APPLICATION NO.	FILING DATE	FIRST NAMED INVENTOR	ATTORNEY DOCKET NO.	CONFIRMATION NO.
10/785,209	02/24/2004	Ronald P. Hohmann JR.	PHO-236 CIP	8805
48745	7590	12/28/2006		
SILBER & FRIDMAN 1037 ROUTE 46 EAST SUITE 207 CLIFTON, NJ 07013			EXAMINER DEVOTI, PAUL D	
			ART UNIT	PAPER NUMBER
			3637	
SHORTENED STATUTORY PERIOD OF RESPONSE		MAIL DATE	DELIVERY MODE	
3 MONTHS		12/28/2006	PAPER

Office Action Summary	Application No. 10/785,209	Applicant(s) HOHMANN, RONALD P.	
	Examiner Paul Devoti	Art Unit 3637

Hohmann (US 4598518) Figure 3

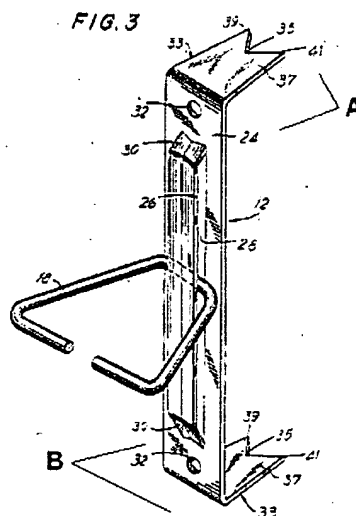
9. Regarding claims 1-4, Hohmann discloses a wall anchor (12) comprising a plate-like body having two major faces in the form of a mounting surface and an outer surface. The wall anchor (12) comprises legs (A, B) with portions that extend perpendicularly from the body of the anchor and have channels (32). The mounting surface of the wall anchor (12) forms a covering portion that would preclude the penetration of air and moisture. An apertured receptor portion (26, 28) has a veneer tie (18) that is threadedly disposed through the aperture (28). Hohmann does not disclose the wall anchor has at least one strengthening rib. Wilhelmi discloses a bracket assembly made of sheet metal having a plurality of strengthening ribs (23) adjacent apertures (4.1, 4.2, 4.3). It would have been obvious to one having ordinary skill in the art at the time of invention to modify Hohmann's wall anchor to include at least one strengthening rib parallel to the apertured receptor portion as taught by Wilhelmi, as it is well known in the art to add ribs to sheet metal members, as they provide reinforcement by adding strength and rigidity to the sheet metal. It would have been obvious to one having ordinary skill in the art to have the anchor constructed to meet a 100 lbf tension

and compression rating, as this would be a matter of obvious design choice. The anchor would obviously be required to have a high strength, as it is used to hold wall members together.

11. Regarding claim 5, Hohmann in view of Wilhelmi discloses everything previously mentioned, including each leg terminates in at least two points (39, 41).

12. Regarding claim 6, Hohmann in view of Wilhelmi discloses everything previously mentioned, including the legs (A, B) have a portion folded inwardly and downwardly towards the mounting surface.
